UNITED STATES  
NUCLEAR REGULATORY COMMISSION  
WASHINGTON, D. C. 20555

SUBJECT: SUMMARY OF MEETING WITH SOUTHERN CALIFORNIA EDISON -  
SITE SPECIFIC EARTHQUAKE PROGRAM

SCE/TERA PRESENTATION  
SITE SPECIFIC EARTHQUAKE PROGRAM  
SAN ONOFRE UNIT 1  
OCTOBER 6, 1978

Close In Mesh Size Study (defocussed)

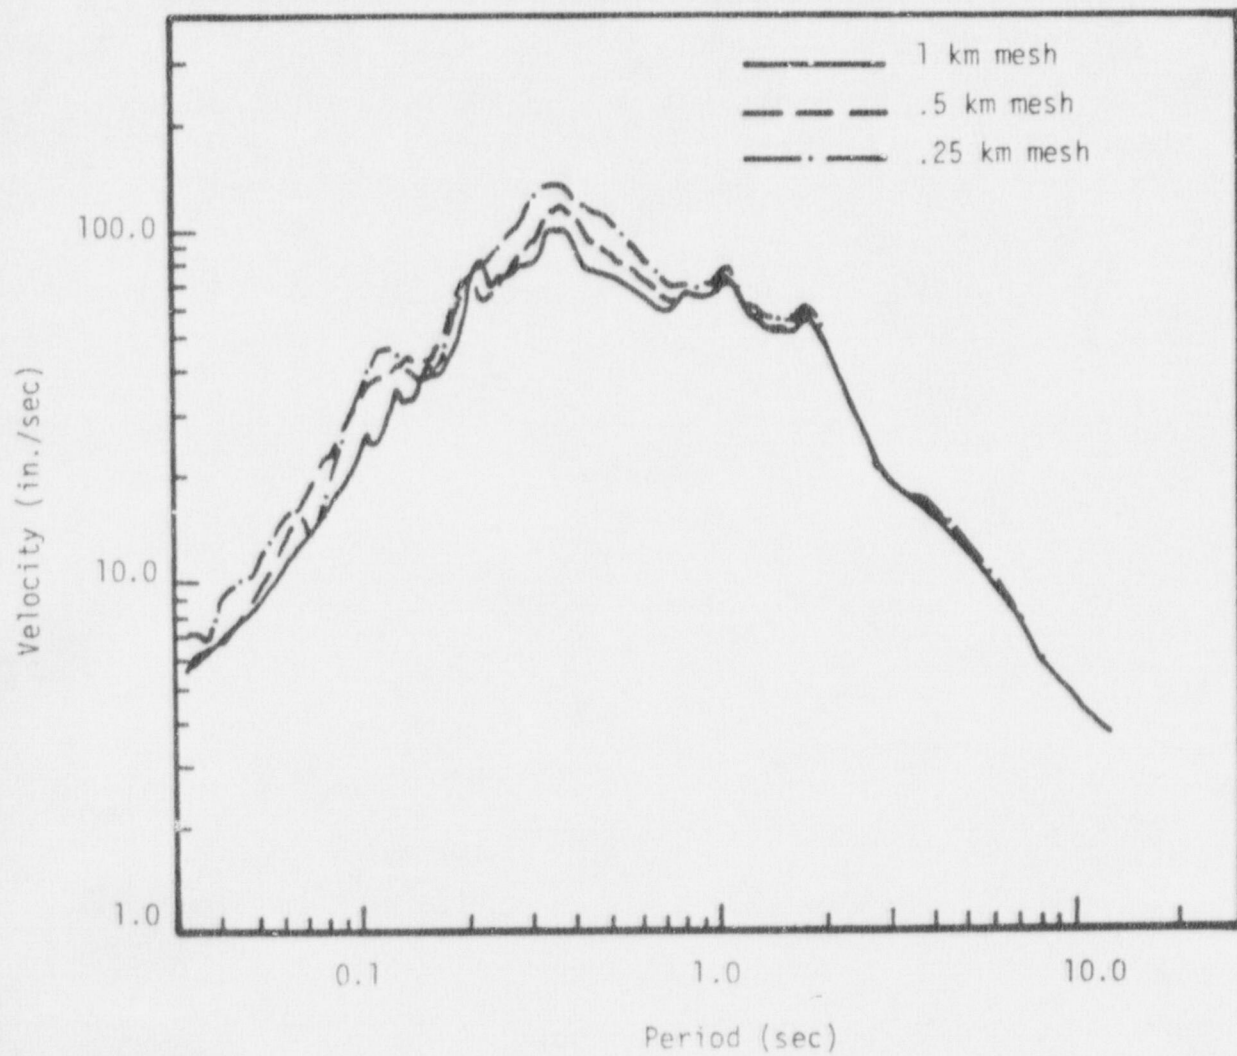
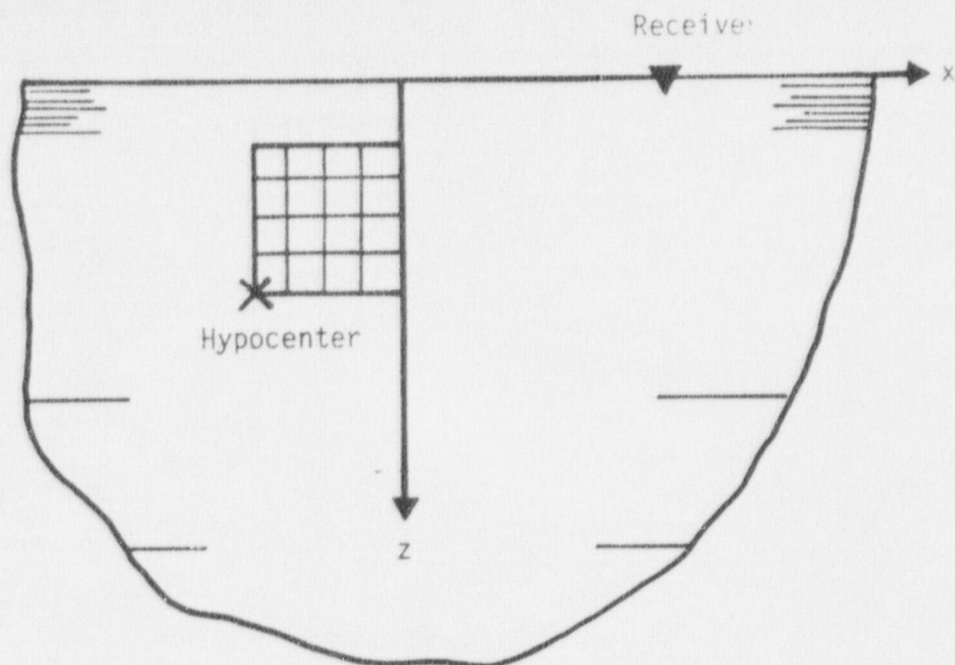
## MESH SIZE

1. COMPUTE GROUND MOTION FOR HIGHLY REFINED COHERENT RUPTURE.
2. COMPARE REFINED RESULTS WITH RESULTS FROM REPORTED METHOD TO ASSESS ACCURACY.
3. QUANTIFY RANDOMNESS AND APPROXIMATIONS IN REPORTED METHOD IN TERMS OF RANDOMNESS INTRODUCED INTO COHERENT RUPTURE.
